NRL/MR/7441--94-7516

Digital Mapping, Charting, and Geodesy Analysis Program Technical Review of Vector Smart Map Prototypes 1 and 2

January 19, 1995

Figure 12. Overlay of V_{Map} and ITD built-up area features

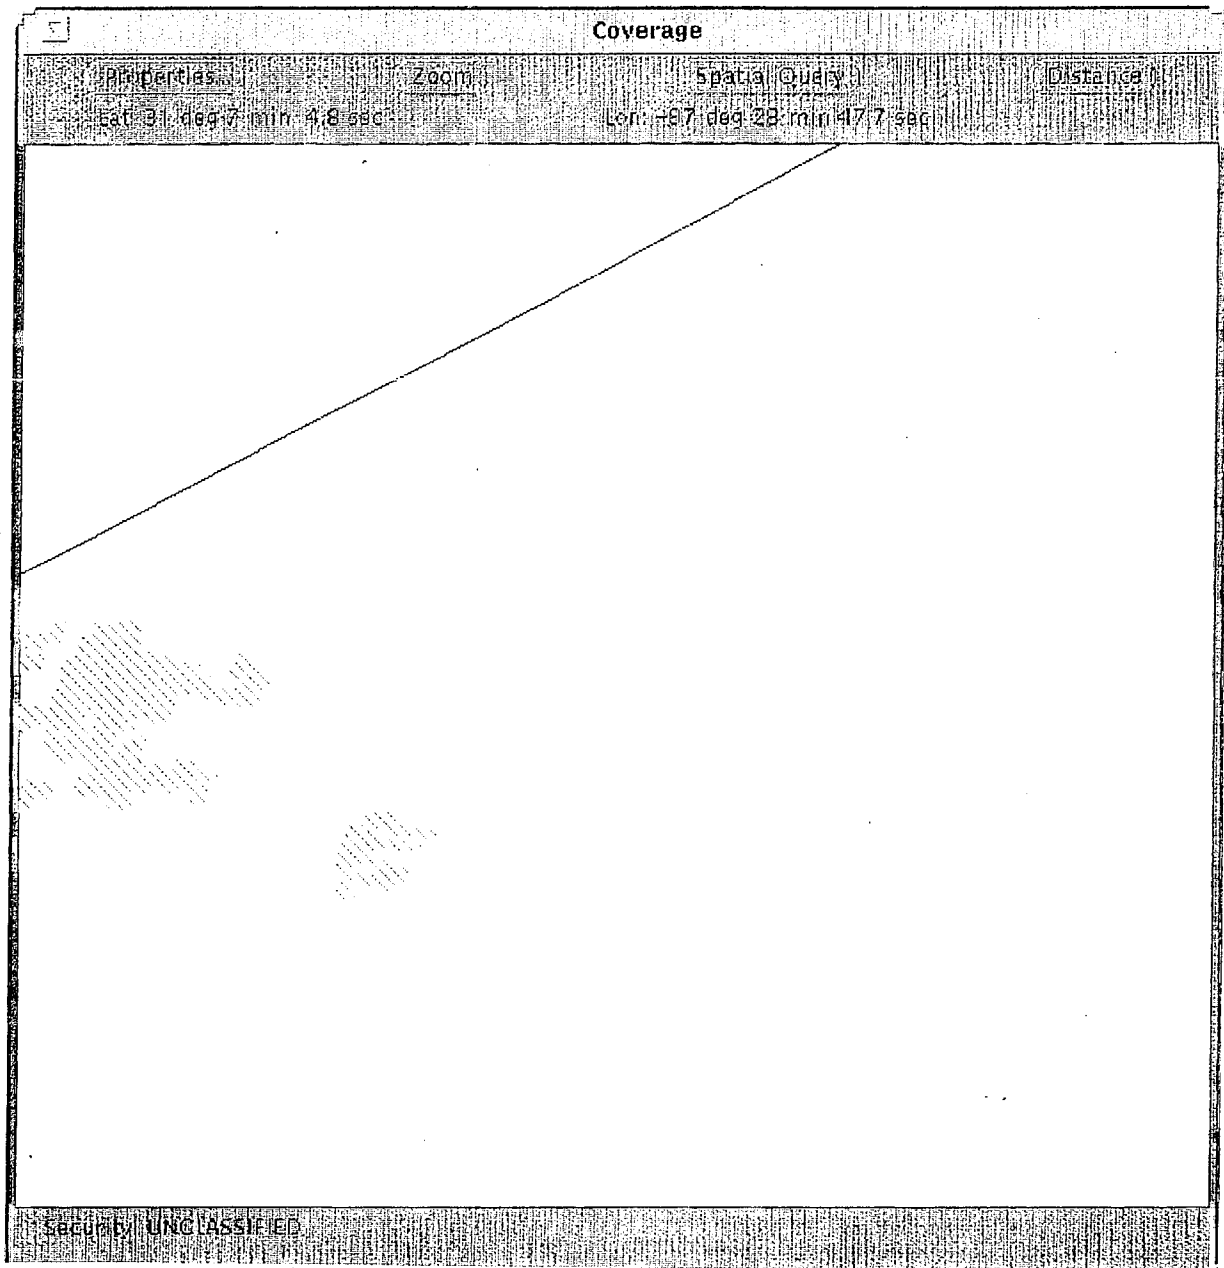
Figure 12 is an overlay of the Built-up Area (AL020) features in ITD and V_{Map} . ITD is represented in yellow and V_{Map} in diagonal red stripes. As can be seen, the Built-up areas in ITD are more extensive than in V_{Map} . This may be due to the different levels of attribution in each database. In ITD, Built-up Area has no attributes, but in V_{Map} it can be categorized by density. All of the Built-up Areas appearing in V_{Map} are classified as "Dense." The following question arises: Will V_{Map} contain only "dense" Built-up Areas, or were these the only Built-up Areas digitized for this particular implementation of V_{Map} ? In either case, assuming that ITD is correct, the remaining areas need to be added to V_{Map} .

Figure 13. Road/bridge discrepancies among V_{Map} , ITD, and source map

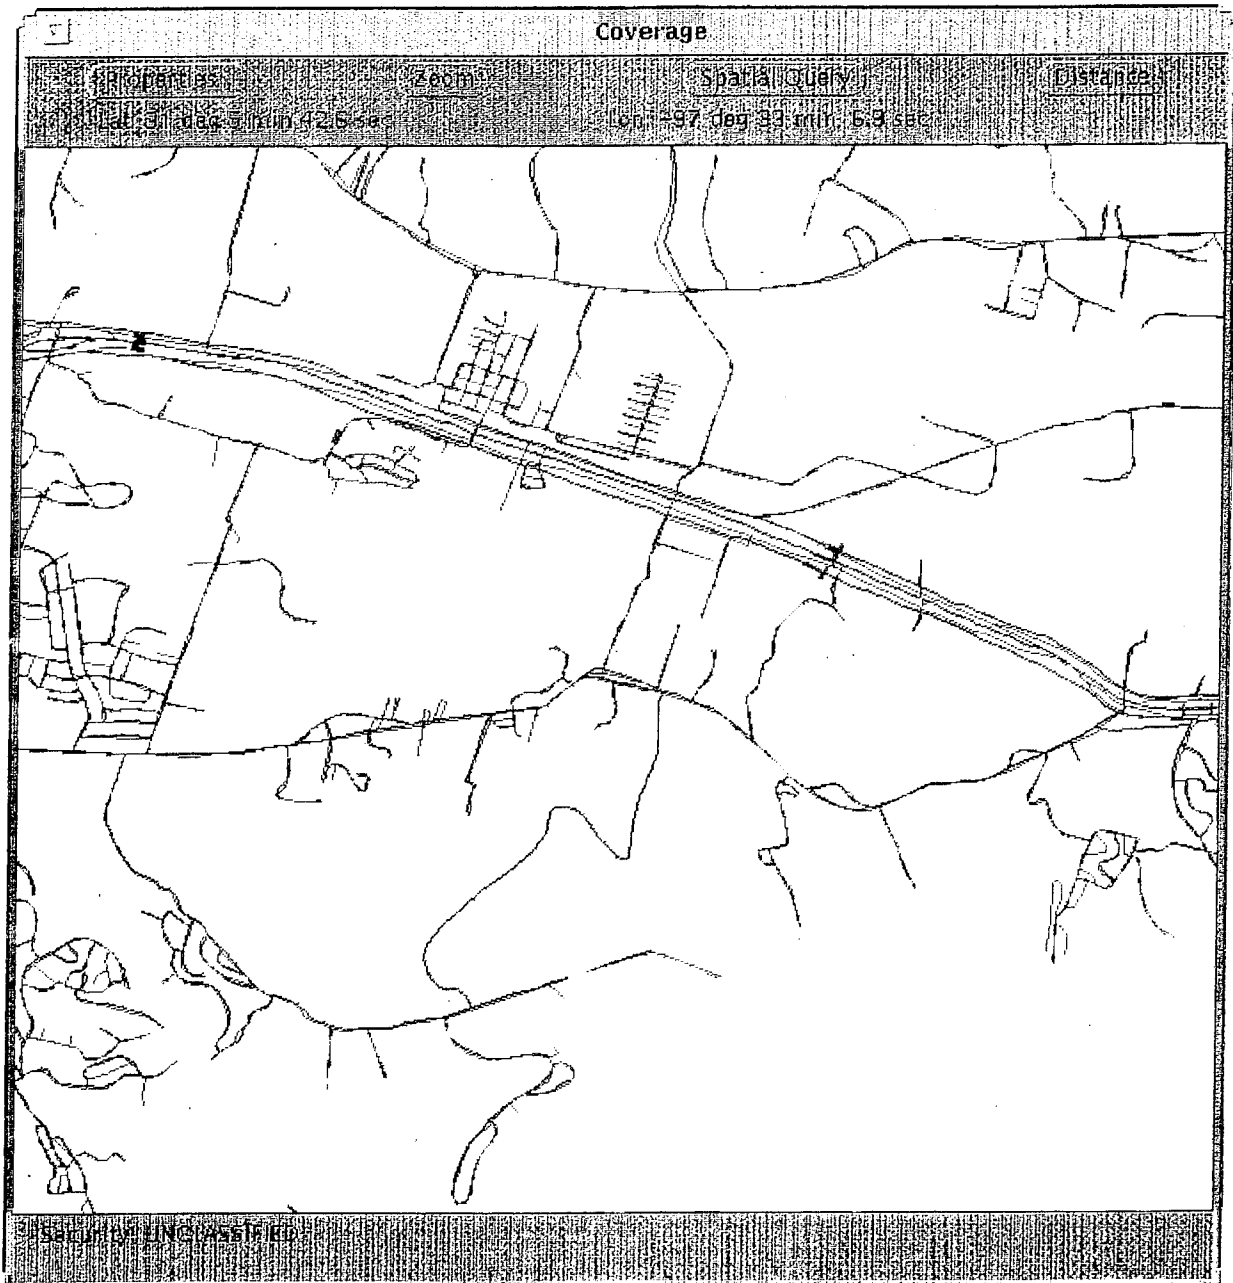
In Figure 13, ITD Roads (AP030) are blue and V_{Map} Roads are red, ITD Bridges (AQ040) are green, and V_{Map} Bridges are black. In the bottom center of the figure, a road classified as paved and all weather is included in ITD and not shown on the hardcopy map, sheet 6446 II, series V782, edition 5-DMATC, Killeen. There are also smaller roads of all types scattered throughout the figure that are omitted from ITD. Finally, in the northwestern corner of the figure, three bridges are depicted by V_{Map} , while none are shown by ITD.

Figure 14. Road/bridge discrepancies between V_{Map} and ITD

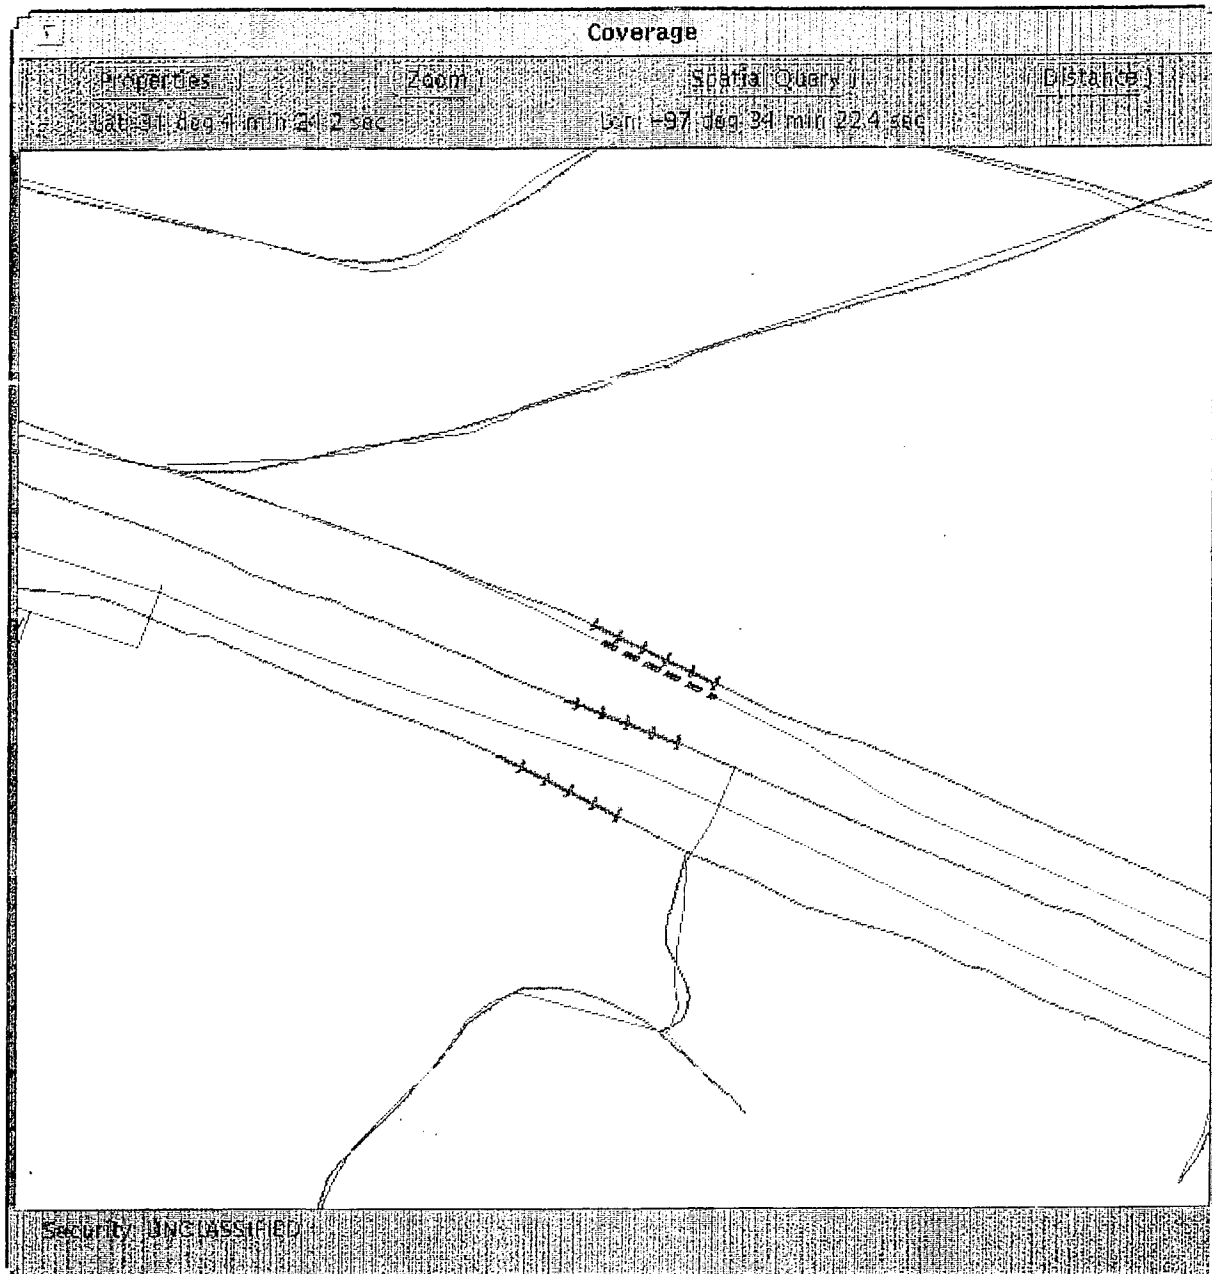
Figure 14 uses the same color scheme as Figure 13. In Figure 14 a section of highway is shown by ITD to have three bridges, but only one by V_{Map} . Also evident in this figure is the lack of agreement on the placement and shape of ITD and V_{Map} features. There is a constant offset between ITD and V_{Map} of .02 to .03 mi (106 to 158 feet) for all features in all coverages.

Figure 15. River/stream discrepancies between V_{Map} and ITD

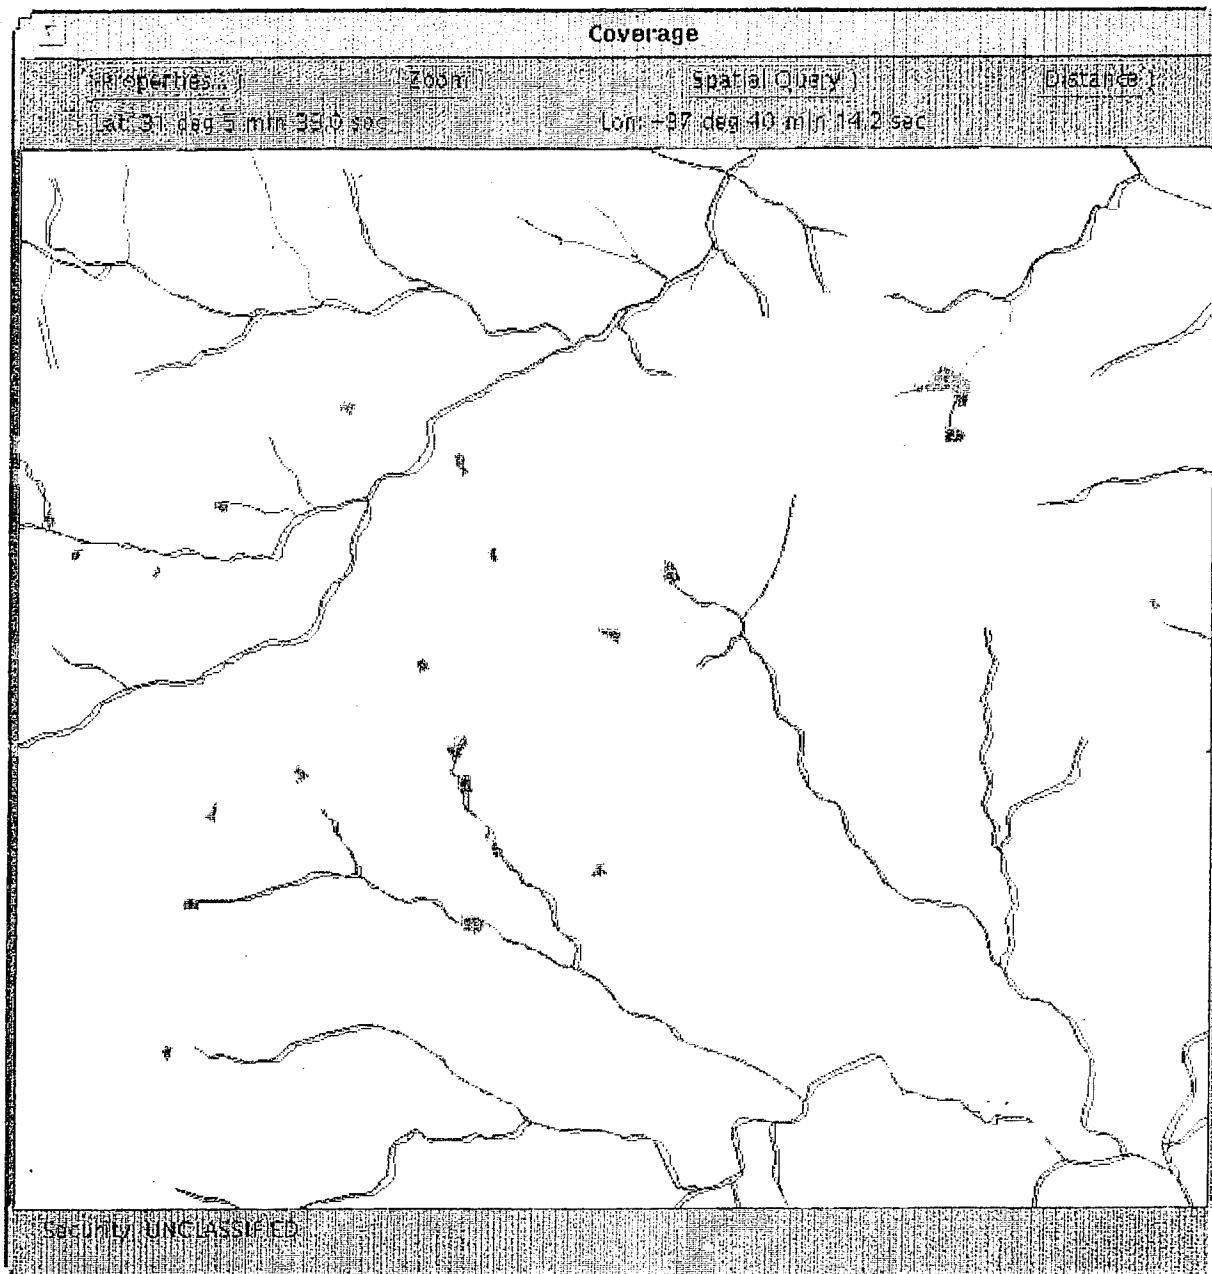
Figure 15 shows ITD River/Stream (BH140) line features in blue, V_{Map} River/Stream line features in red, V_{Map} Lakes/Ponds (BH080) in blue, and ITD Common Open Water (SA010) in orange. Of importance in this figure are the small Lakes/Ponds that are omitted from ITD and the various small river branches that are included by one database and not the other.

Figure 16. Reservoir classification disagreement between V_{Map} and ITD

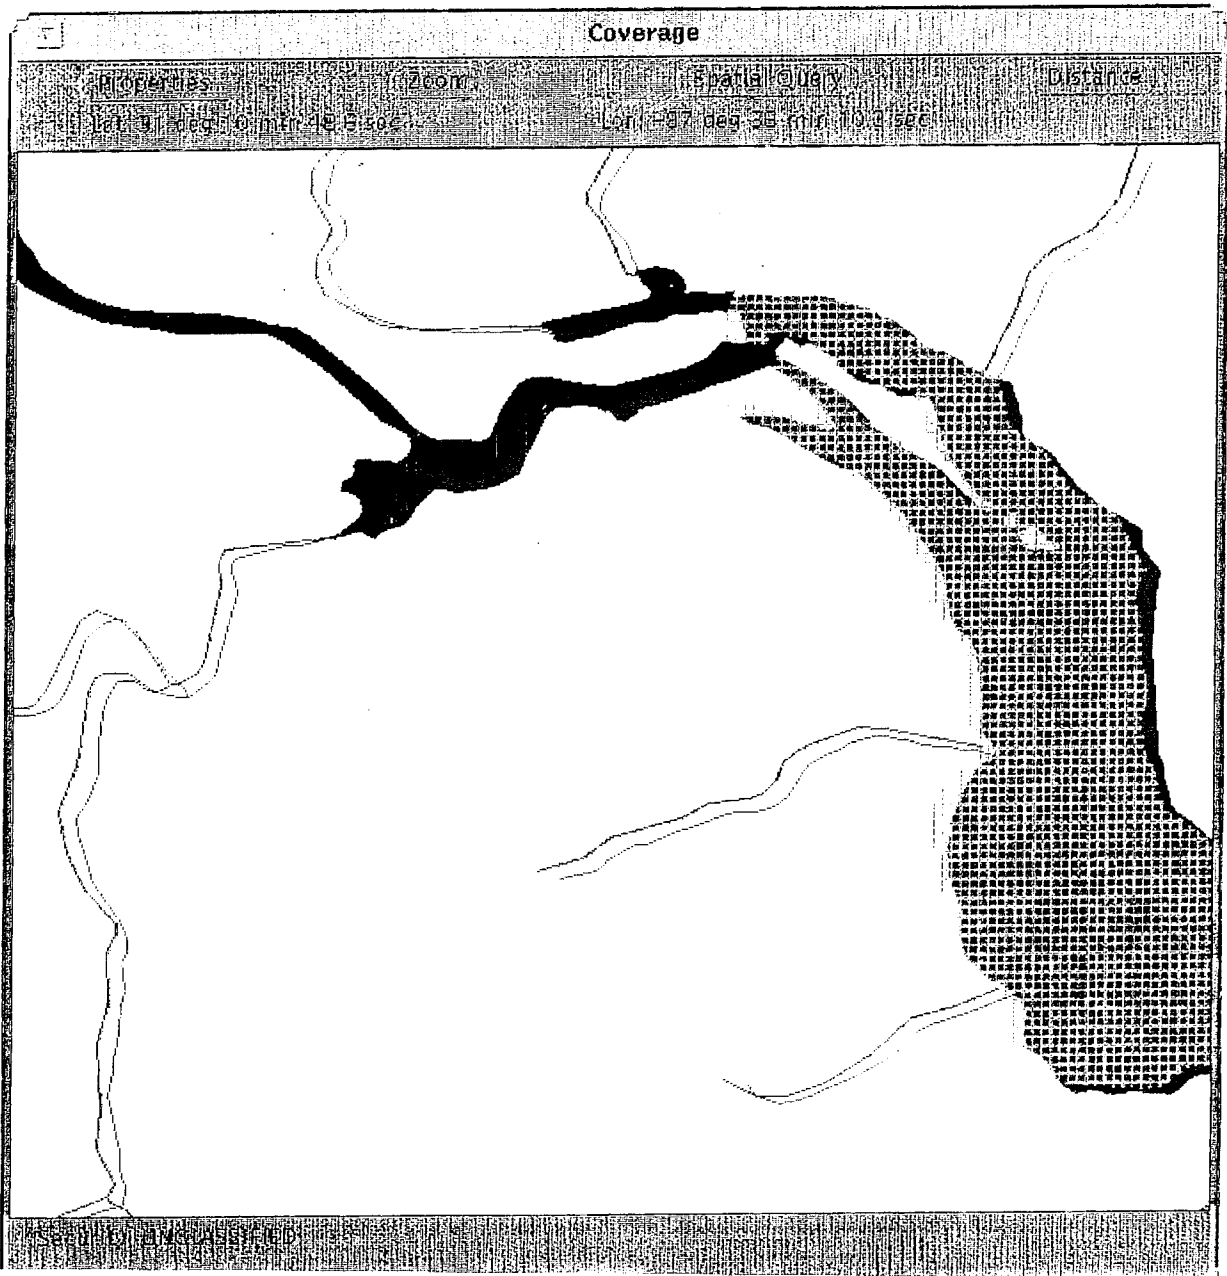
In addition to the features and color scheme of Figure 15, Figure 16 includes ITD River/Stream area features in dark blue, V_{Map} River/Stream area features in red, and Reservoir (BH130) in medium blue. This figure shows a disagreement on the classification of the extreme western end of the reservoir. ITD classifies it as both a river line and area feature, while V_{Map} labels it an extension of the reservoir area feature.

Figure 17. Ford differences between V_{Map} and ITD

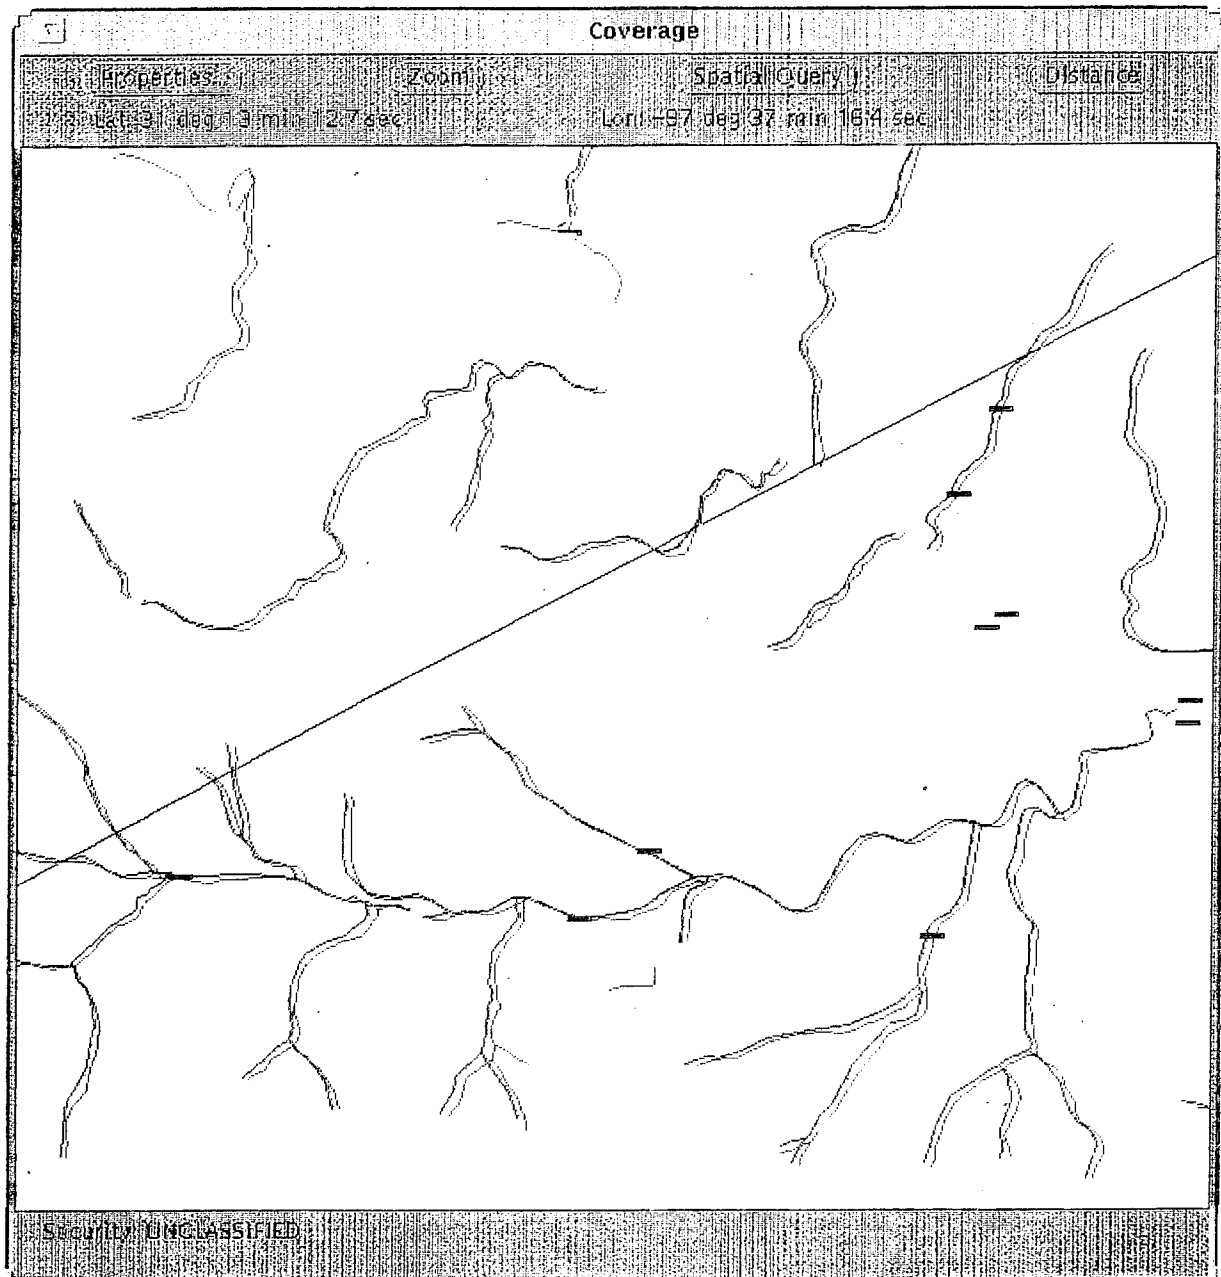
Figure 17 shows ITD Rivers/Streams (BH140) in blue, V_{Map} Rivers/Streams in red, ITD Fords (BH070) in gold, and V_{Map} Fords in black. In this figure, there is disagreement between the number and location of fords in the figure. In addition, the ITD fords are not on the ITD river.
